# SERVICE BULLETIN

## INSTRUMENT CLUSTER 3-PACK CONVERSION – AC TO ROCHESTER

500 Model 369HS Helicopter, Serial No. 0411 through 08741

500 Model 369HM Helicopter, Serial No. 0248 through 0292

**Figure 1. Instrument Cluster 3-pack Conversion (Sheet 1 of 2)**

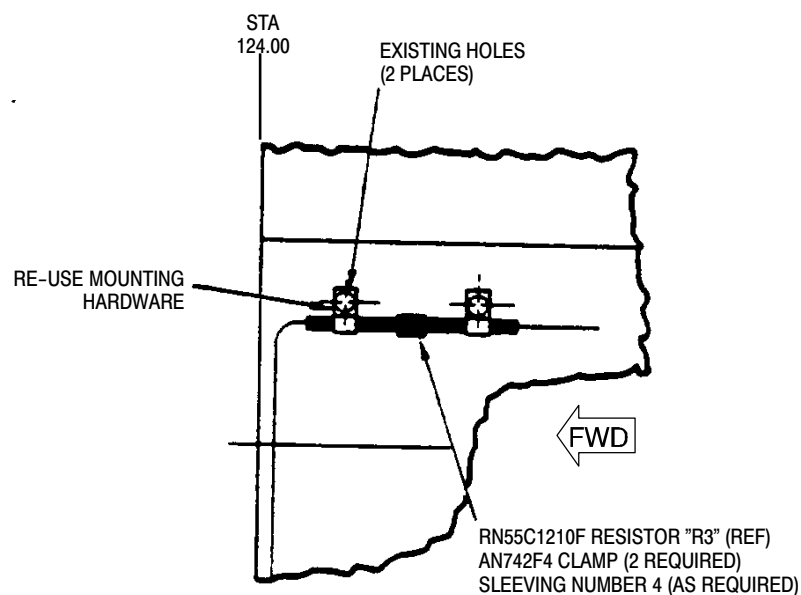
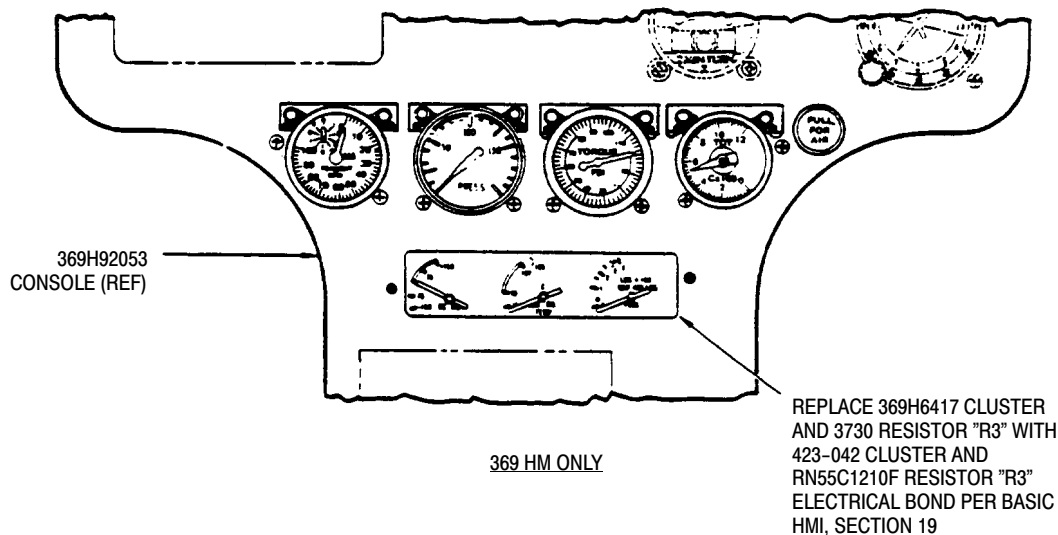
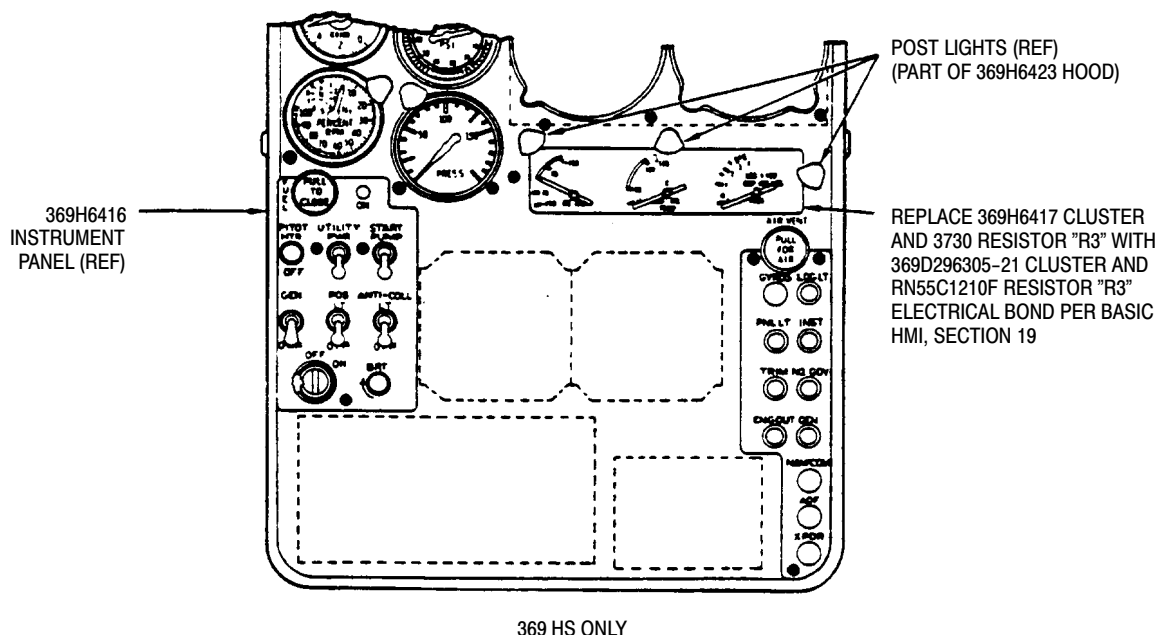
The information given in this Service Information Notice lists a procedure for conversion from AC to Rochester instrument cluster 3-pack assembly. The AC instrument cluster 3-pack assembly is no longer available from the manufacturer. Therefore, when replacement becomes necessary, it must be replaced with a Rochester instrument cluster 3-pack assembly.

- (1). Turn off electrical power.
- (2). Replace resistor R3 as follows:
  - (a). Open engine compartment access doors. (Refer to Section Basic HMI)
  - (b). Locate existing resistor R3 in engine compartment, right-hand side. Remove and retain mounting hardware. (See Figure 1)
  - (c). Unsolder wires D505C20 and D510B20 from resistor R3 and discard resistor.

- (d). Install new resistor R3. Lap solder wires to resistor and cover with sleeving. (See Figures 1 and 2.)
- (e). Install clamps with hardware retained above. (See Figure 1)
